**Addendum No. 06**

**Subject:** Edward Gideon School  
SDP Contract No. B-055C OF 2018/19

**This Addendum, dated January 8<sup>th</sup>, 2020 shall modify and become part of the Contract Documents for the work of this project. Any items not mentioned herein, or affected by, shall be performed strictly in accordance with the original documents.**

**1 SECURITY ONE-LINE DIAGRAM**  
SCALE: NONE

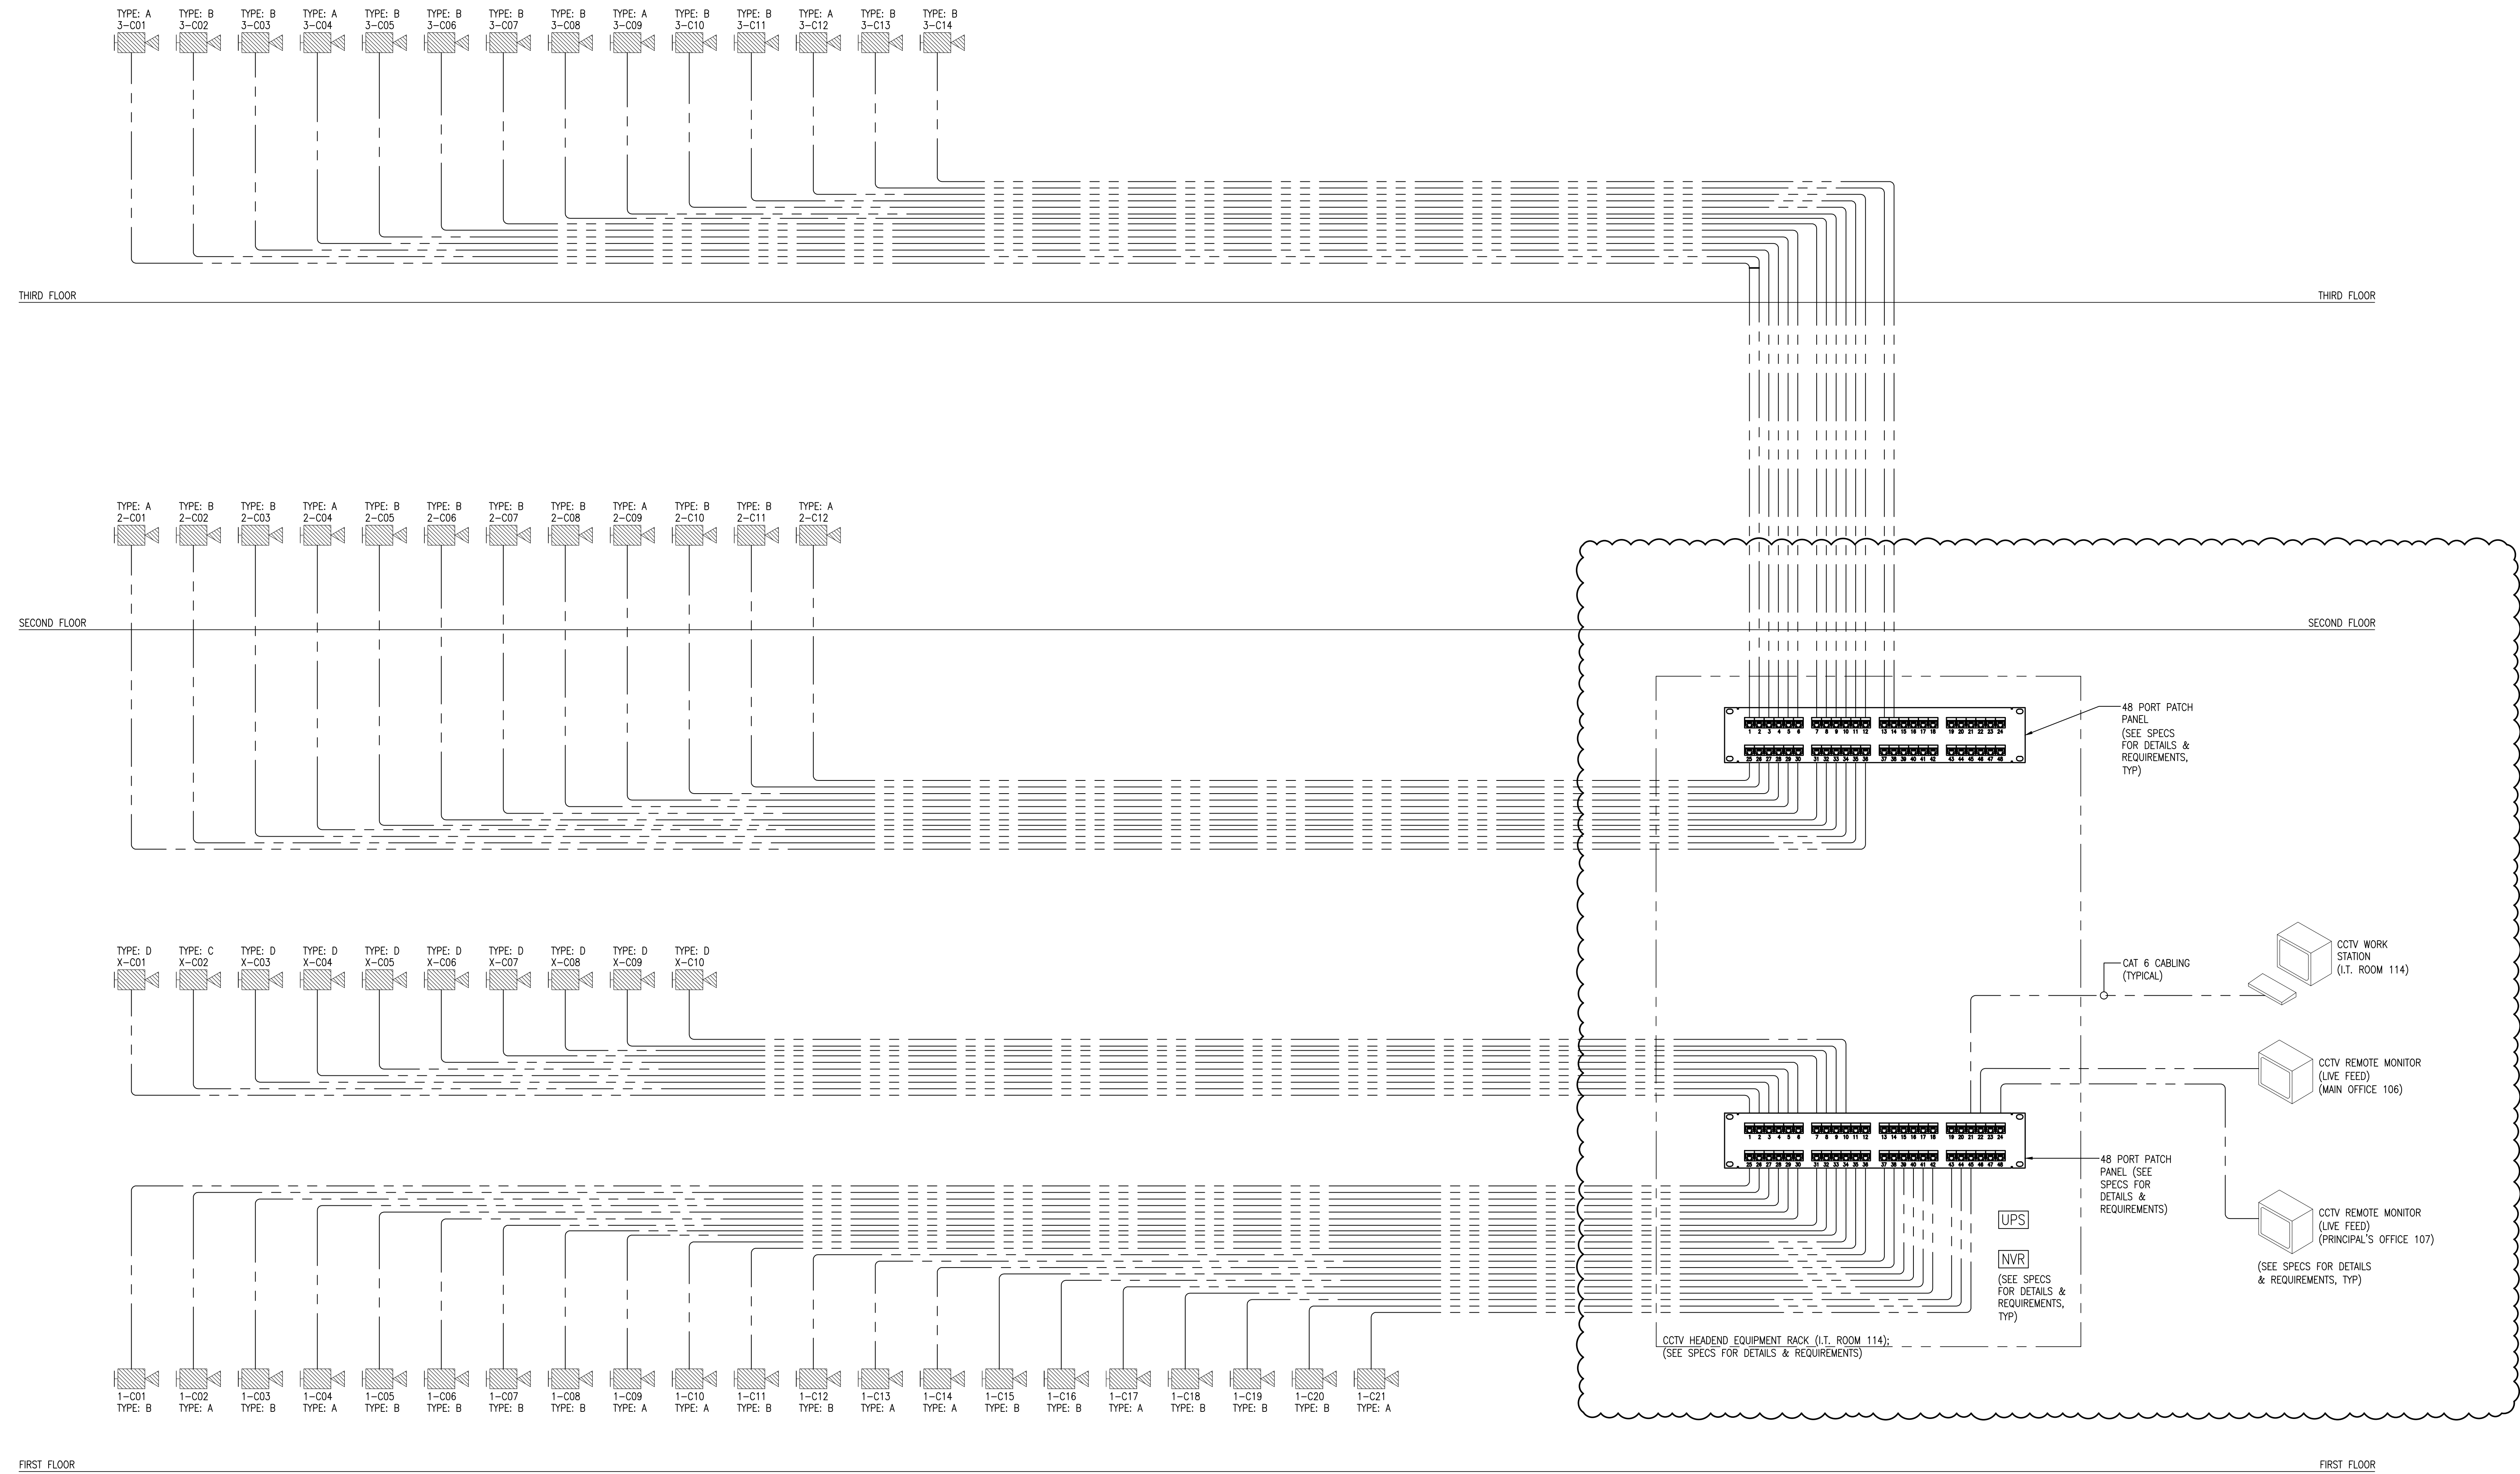
In spec section 28 2300, Part 2.8 (A). it states to Provide (2) CCTV Workstations. The plans only show (1), please advise.

Quantities indicated in spec 282300 are typographical errors; design intent is to provide one (1) CCTV workstation with one (1) 19" (min.) monitor in IT Rm 114 for, with two (2) 43" (min.) remote monitors to be located in each Main Office 106 & Principal's Office 107. Per Key Note #4, verify exact locations & requirements with authorized SDP.
